Draft decision

Queensland

**Draft distribution determination
2010–11 to 2014–15**

25 November 2009

Figure 6.3: Energex actual, estimated and forecast energy consumption (GWh)

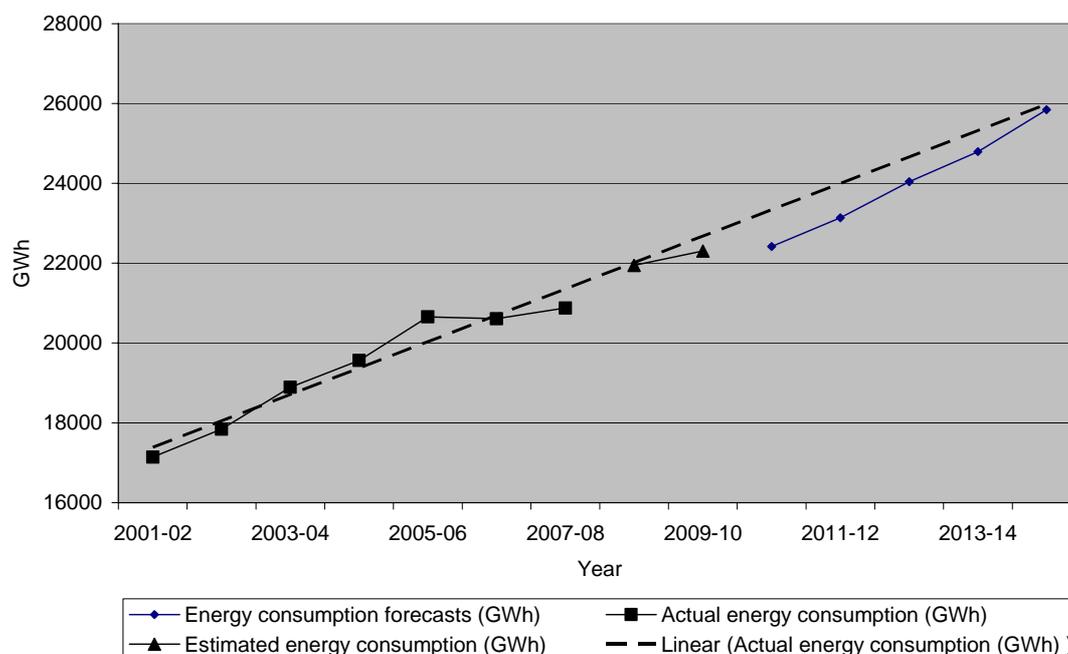
As shown in figure 6.3, Energex’s forecast of energy consumption over the next regulatory control period starts well below the point indicated by the extrapolation of historical data. The AER considers that this is to be expected given the impact of the GFC on economic growth and energy consumption. Energex’s forecast of energy consumption then moves back towards historical trends over the next regulatory control period. The AER notes that this is consistent with the Queensland government budget forecast of below trend state economic growth at the beginning of the next regulatory control period, due to the GFC, followed by recovery back to historical trend growth over the next regulatory control period.²²⁷

Figure 6.4 Ergon Energy actual, estimated and forecast energy consumption (GWh)

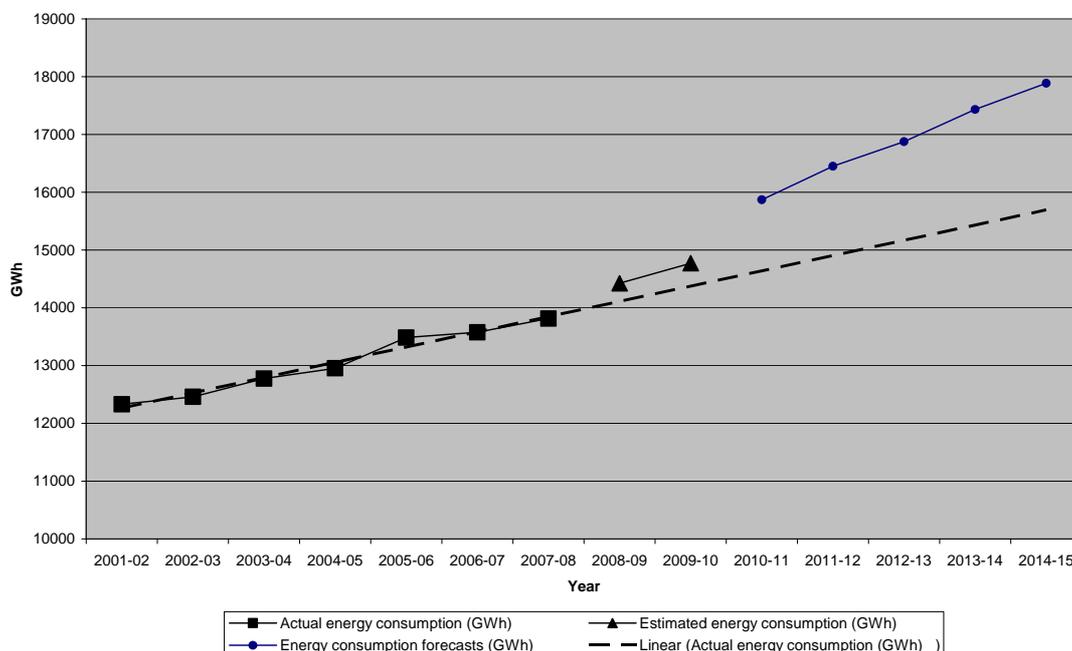
The AER reviewed Ergon Energy’s energy consumption forecasts, as presented in figure 6.4 below. The AER notes that the forecast implies an annual growth rate of 3.9 per cent over the period 2008–09 to 2014–15. This is significantly higher than the 1.9 per cent rate of annual growth experienced over the period 2001–02 to 2007–08.

As shown in figure 6.4, Ergon Energy’s forecast of energy consumption at the start of the next regulatory control period is well above the point indicated by the extrapolation of historical data, and this difference widens over the next regulatory control period.

The AER considers that Ergon Energy’s energy consumption forecast is too high, given the current economic environment.

Figure 8.5: Energex proposed/actual opex and regulated allowances 2005–2015 (\$m, 2009–10)

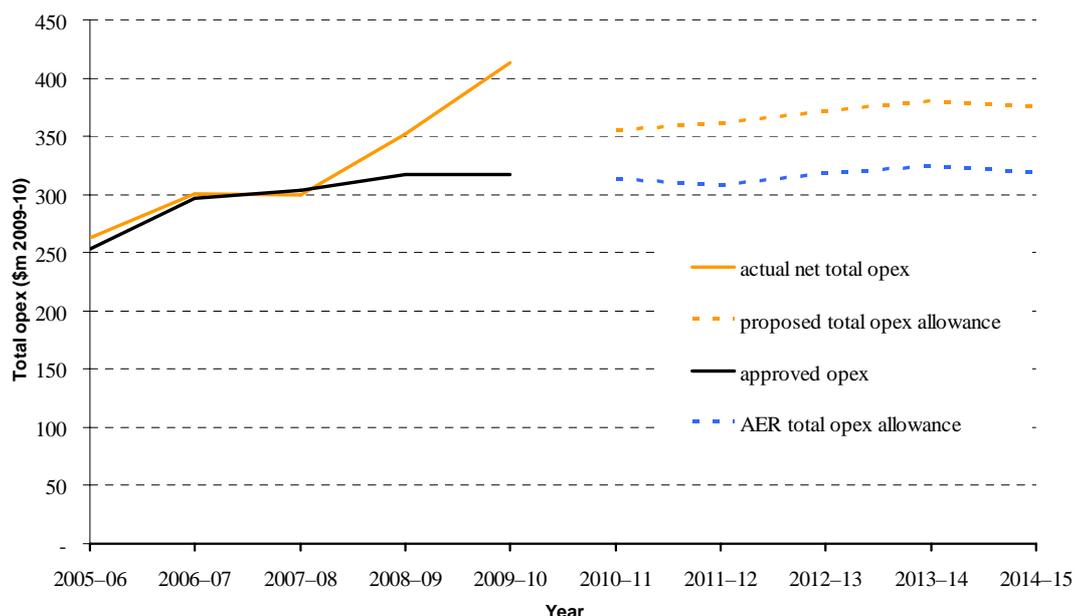
Figure 8.5 illustrates the AER’s draft decision on Energex’s forecast opex compared to its proposed allowance, and current period opex outcomes.

Figure 8.6: Ergon Energy’s proposed/actual opex and regulated allowances 2005–2015 (\$m, 2009–10)

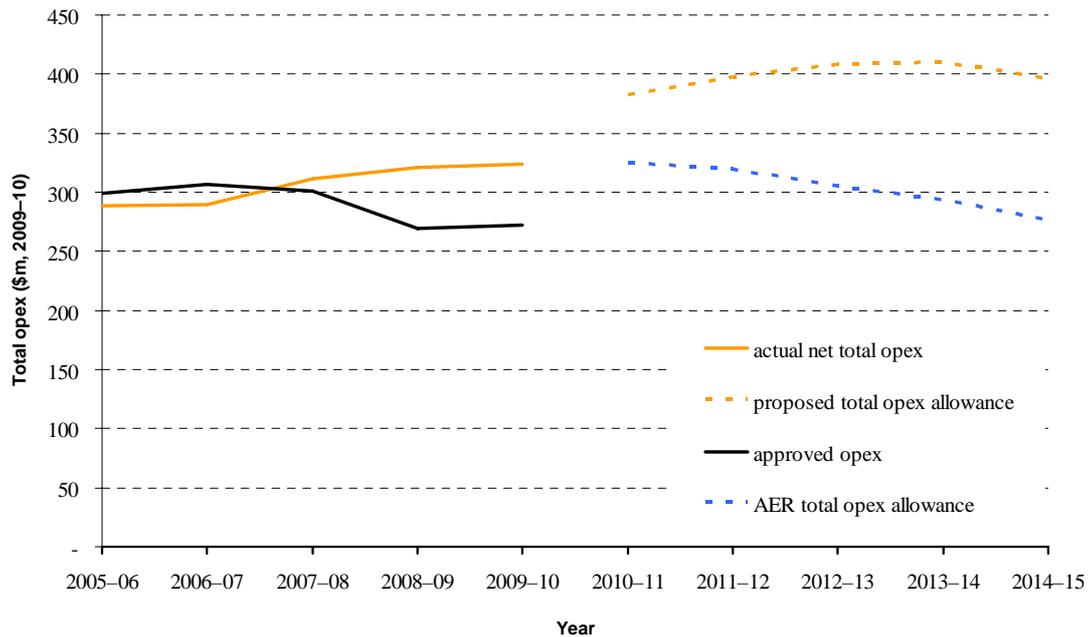
Figure 8.6 illustrates the AER’s draft decision on Ergon Energy’s forecast opex compared to its proposed allowance, and current period opex.
